NO.	DESCRIPTION	DATE
3	PERMIT REVISION 1	04.19.22
4	REV 1 SUB 2	06.10.22
5	REV 1 SUB 3	08.30.22
6	PERMIT REVISION 2	07.06.23
7	PERMIT REV. 2 SUB 2	11.07.23

CLARKSON RESIDENCE
8163 WEST MERCER WAY
MERCER ISLAND, WA 98040
© COPYRIGHT 2022 BRANDT DESIGN, INC. SEATTLE, WA

PERMIT DRAWINGS

1 PROPOSED UPPER LEVEL FLOOR PLAN
1/4" = 1'-0"

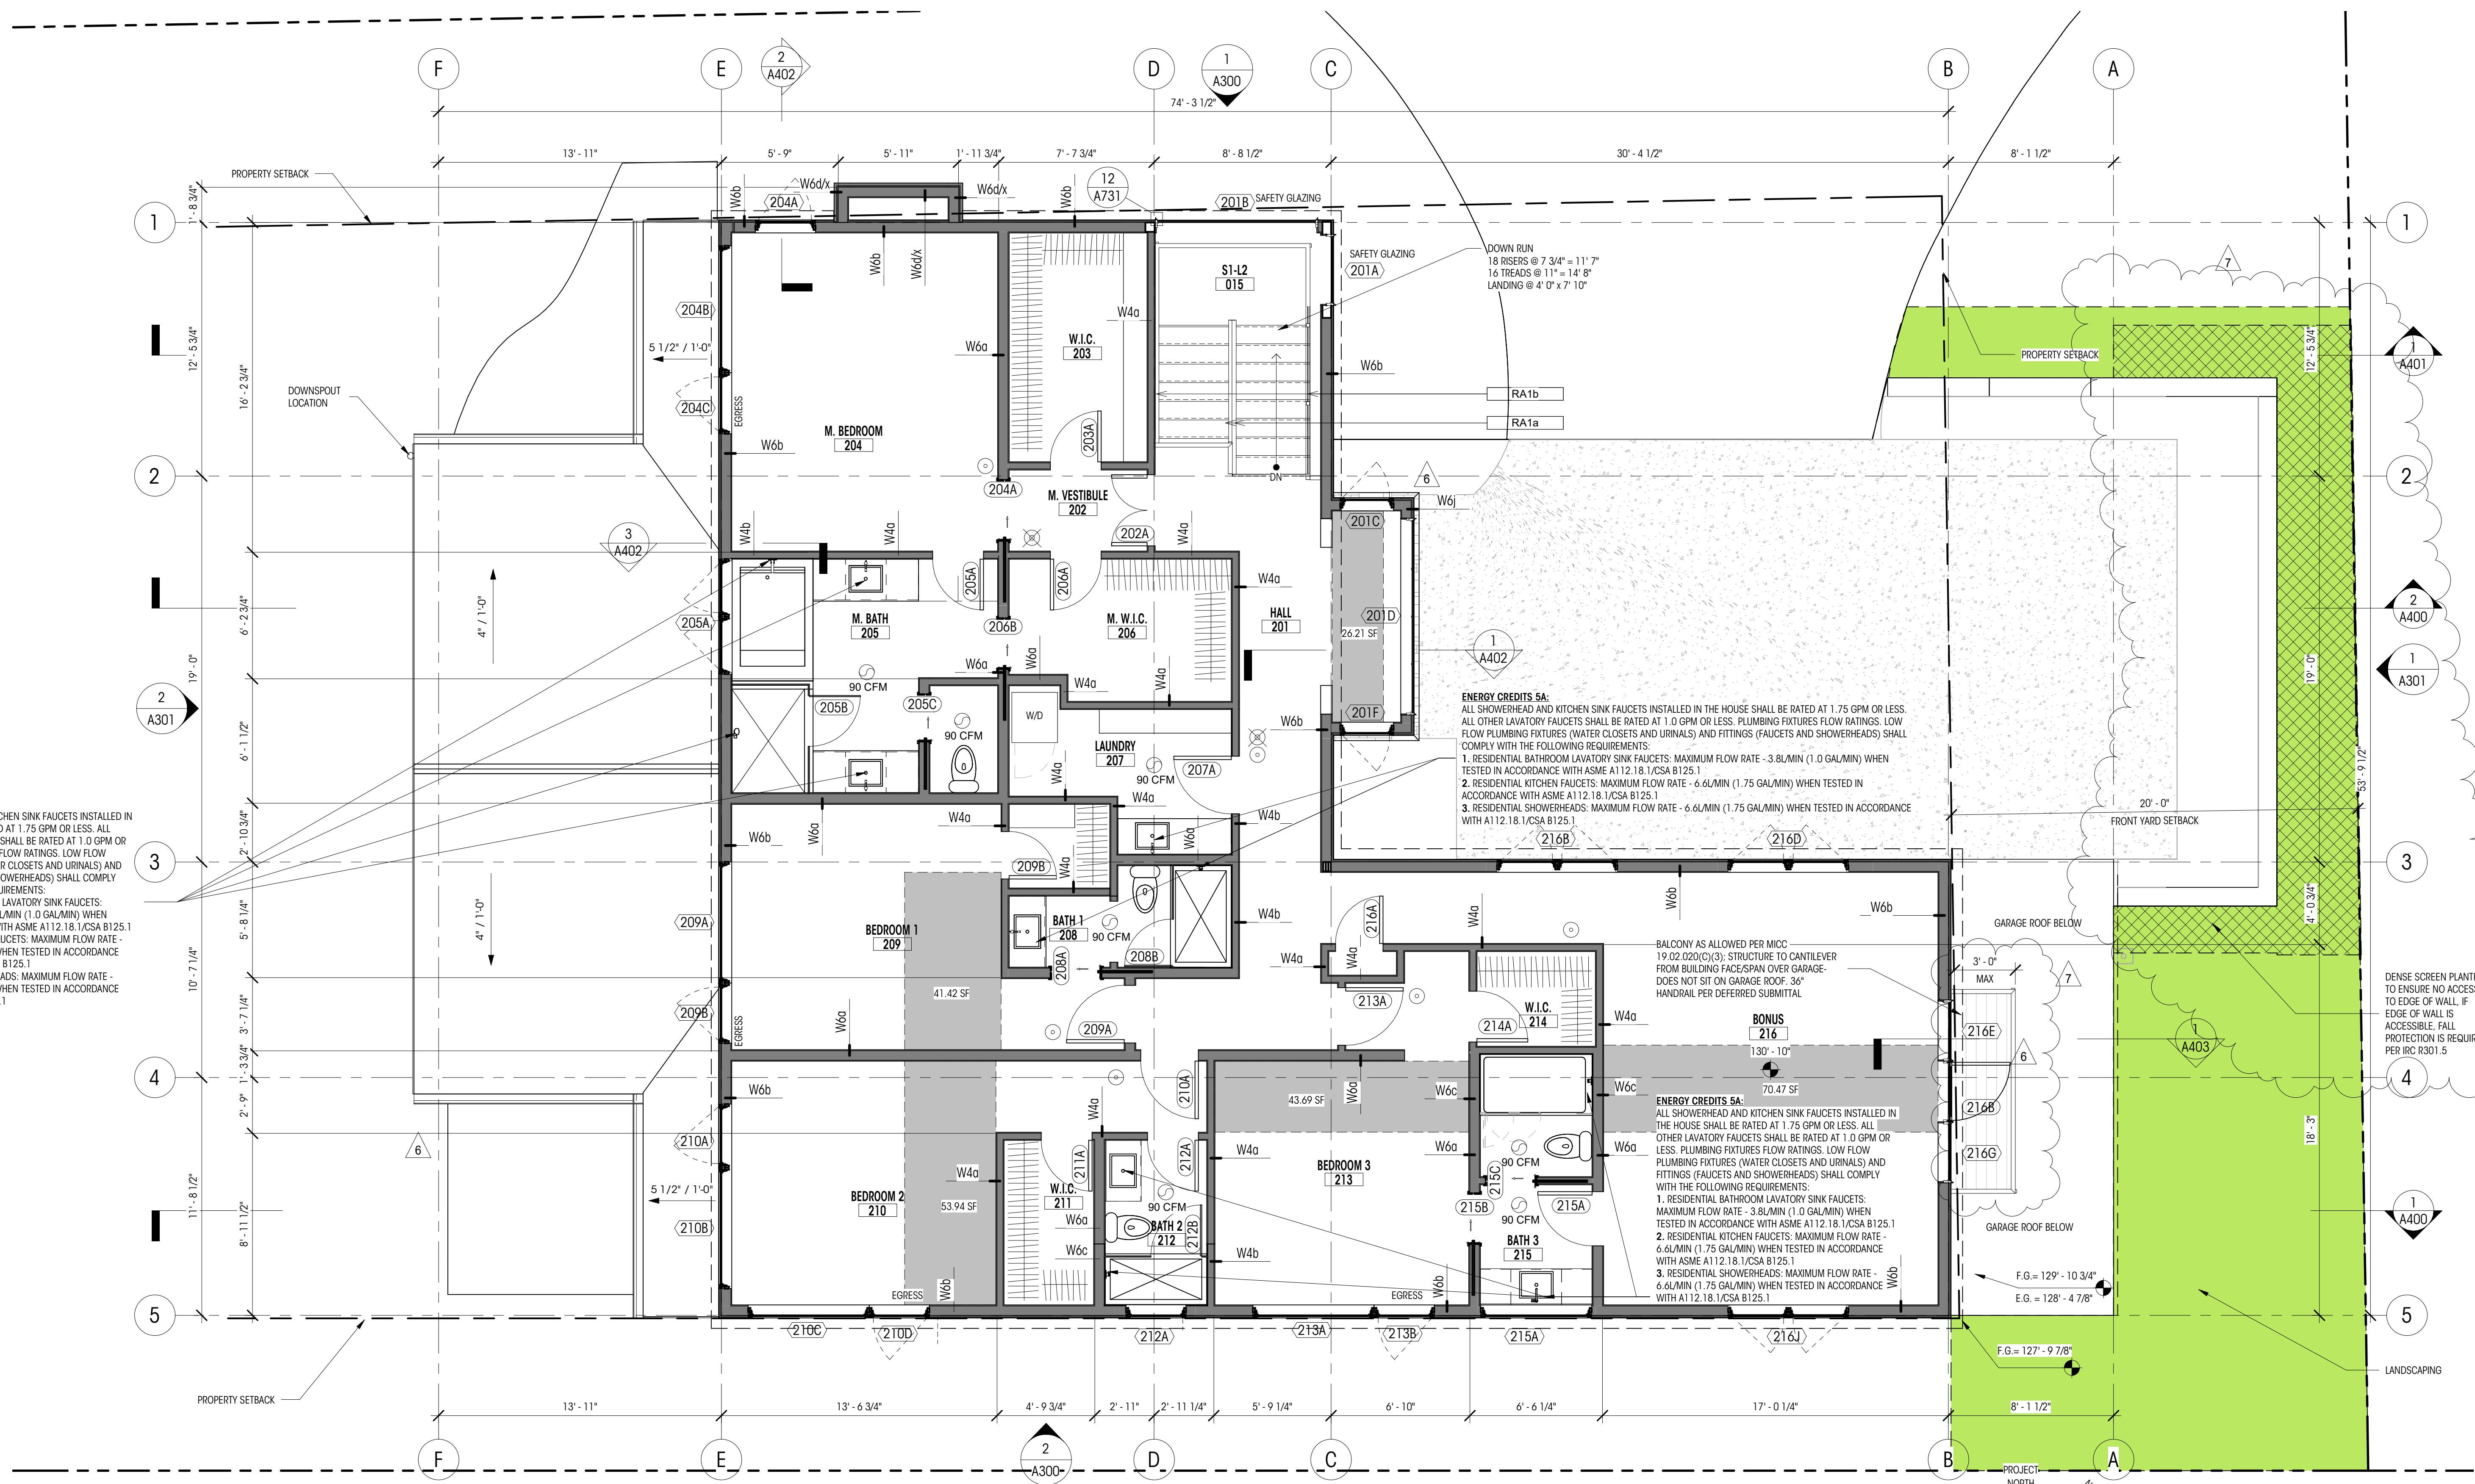
SCOPE OF CHANGES:

- JULIET BALCONY ADDED OFF OF BONUS ROOM
- DENSE SCREEN PLANTING GRAPHIC ADDED BACK IN

EXTERIOR ELEVATIONS

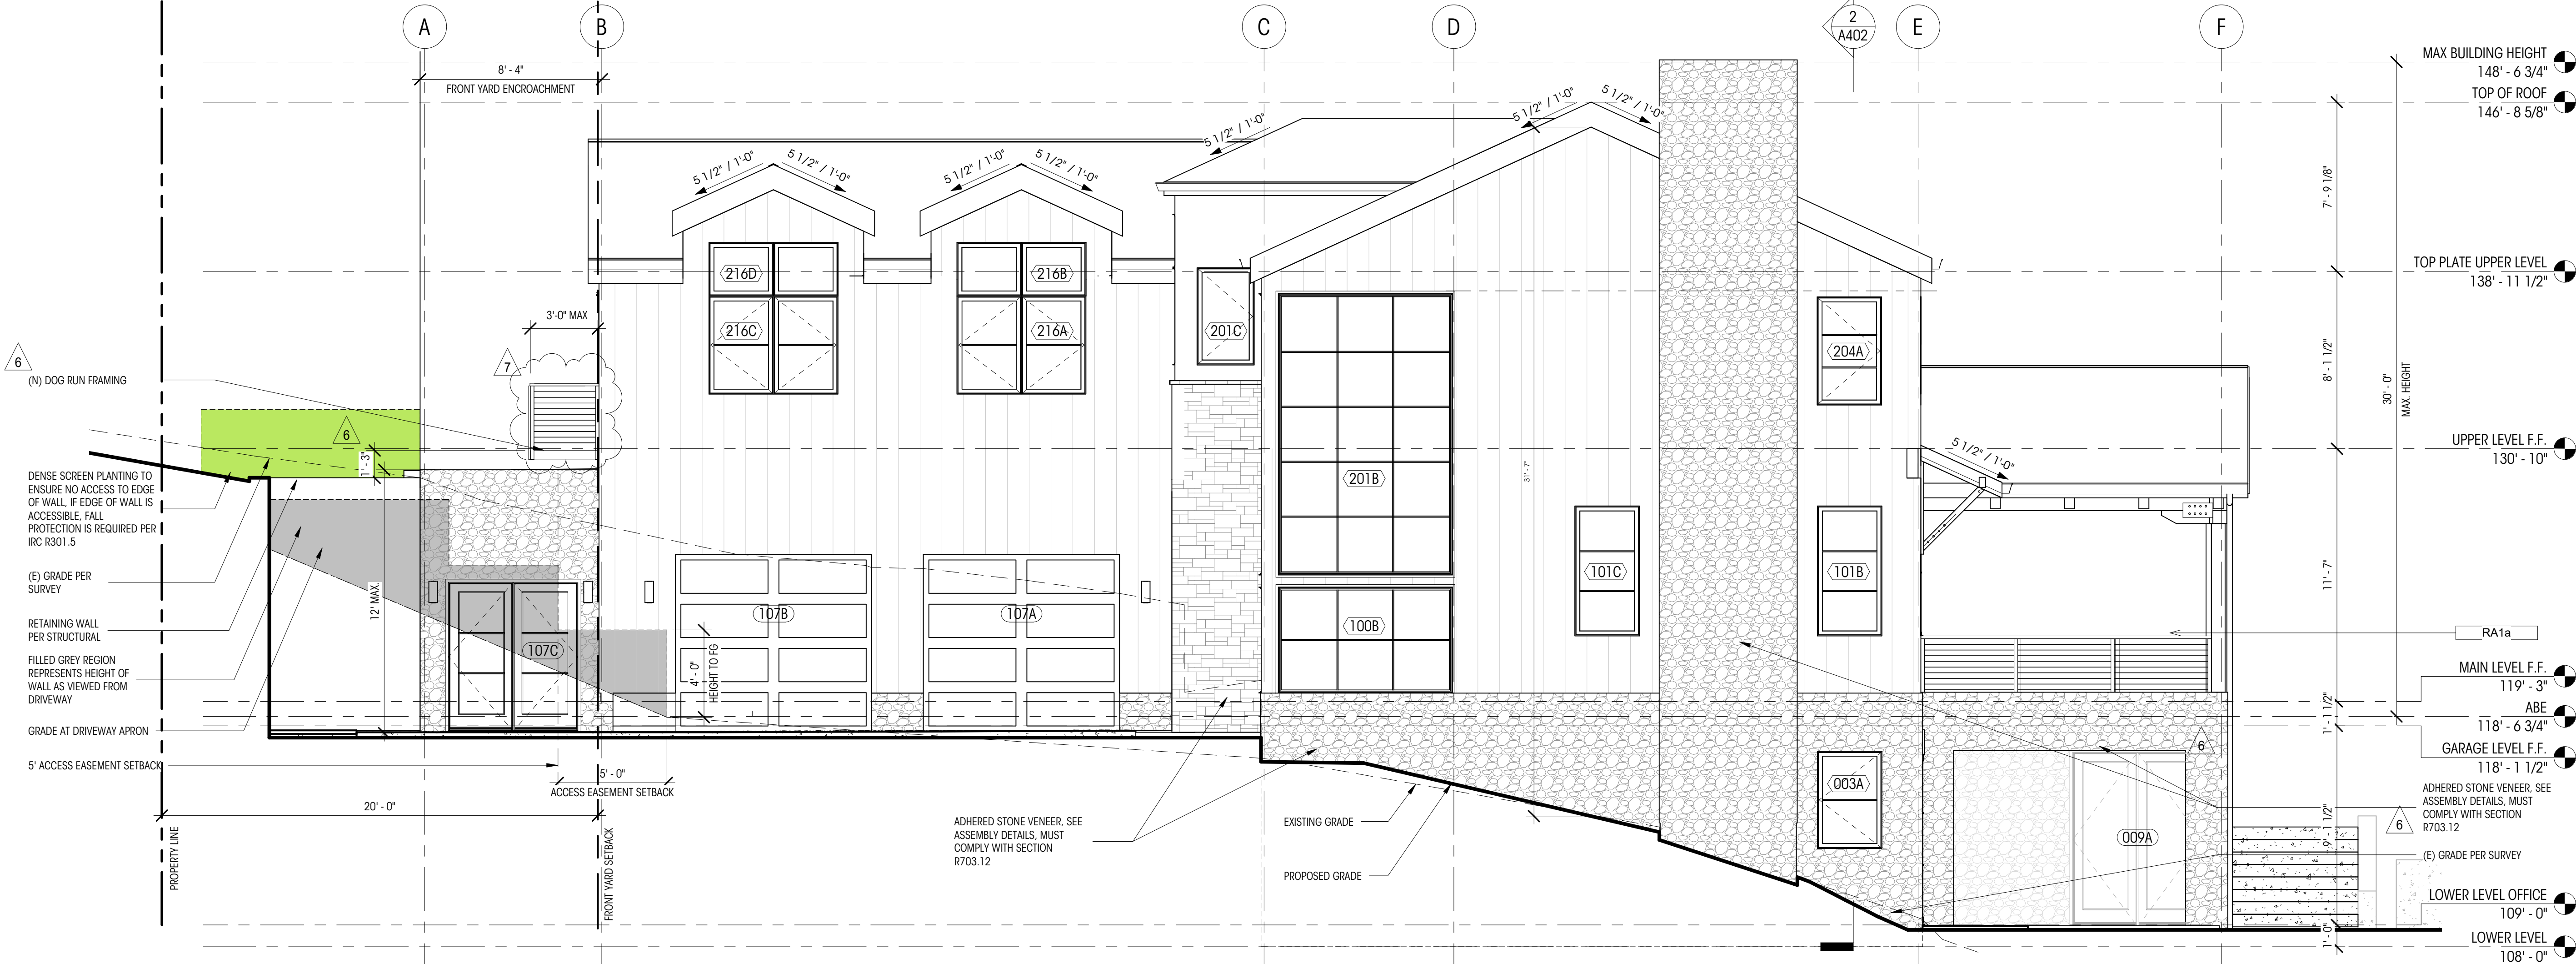
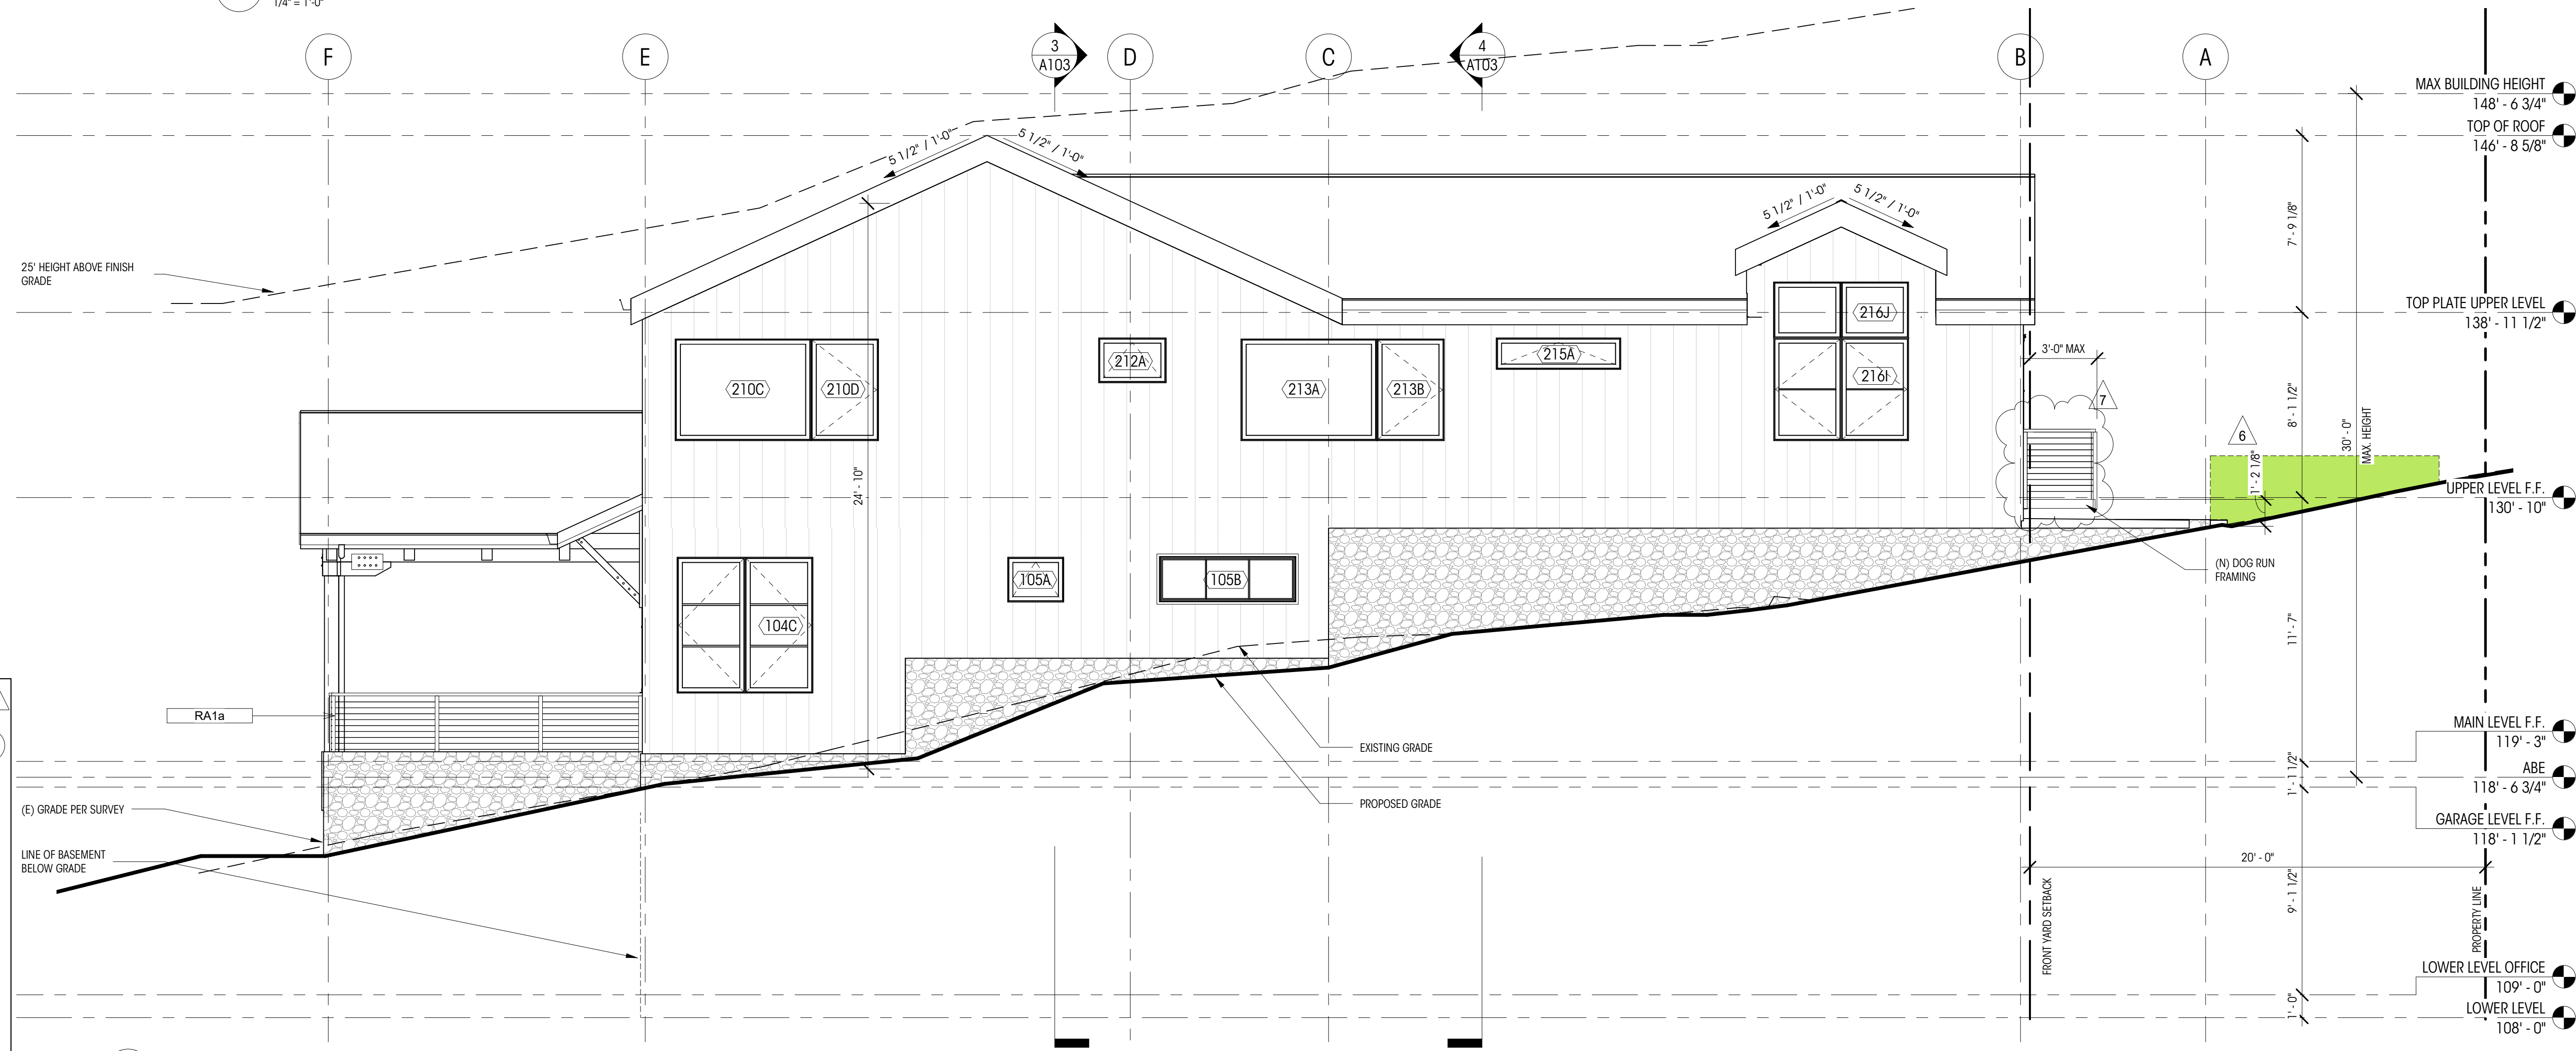
SCOPE OF CHANGES:
ADDITION OF JULIET BALCONY OFF OF BONUS ROOM
